UCM HBS-ME Bldg.

PH – Social Science Research Lab (#50B)

Notes of 18 March Programming Breakout Meeting #1

28 March 2021

#50B PH Social Science Research Lab Option 1

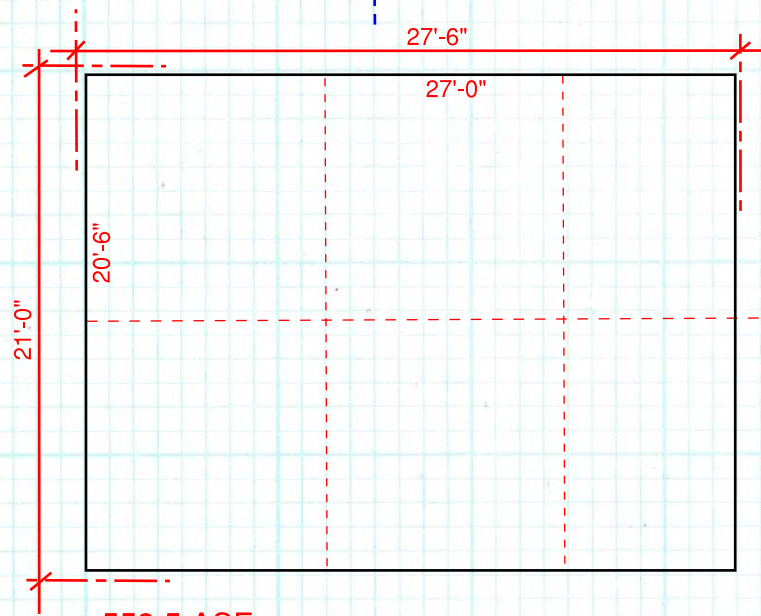
Response: Two Program Plan options were presented, one with the workstations separated from the interaction area and the other without an acoustical separation. At the meeting, the PH representatives appeared to be favoring the option with the acoustical separation, but they wanted to first discuss this with their colleagues. There was also interest in how removeable and/or addable such a partition might be.

#50B PH Social Science Research Lab Option 2

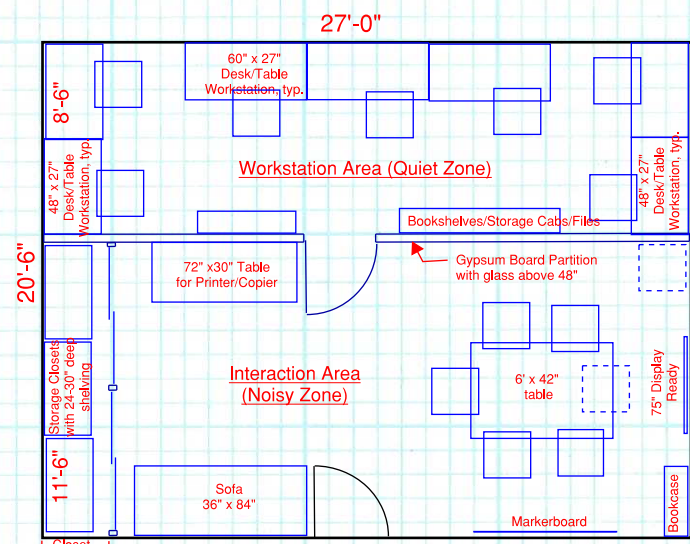
1. Bookcases? Response: Low bookshelves were shown in Option #2 (the option with the acoustical separation) and they were not declared unnecessary by anyone.
2. File Cabinets? Response: Files were shown in Option #2 (the option with the acoustical separation) and they were not declared unnecessary by anyone.
3. Tall Storage Cabinets/Units? Response: The need for the storage of items that are taken to fairs including pop-up tents, folding tables/chairs and supplies (bins, etc.)
4. A place for a printer/copier and associated paper is wanted in each lab.
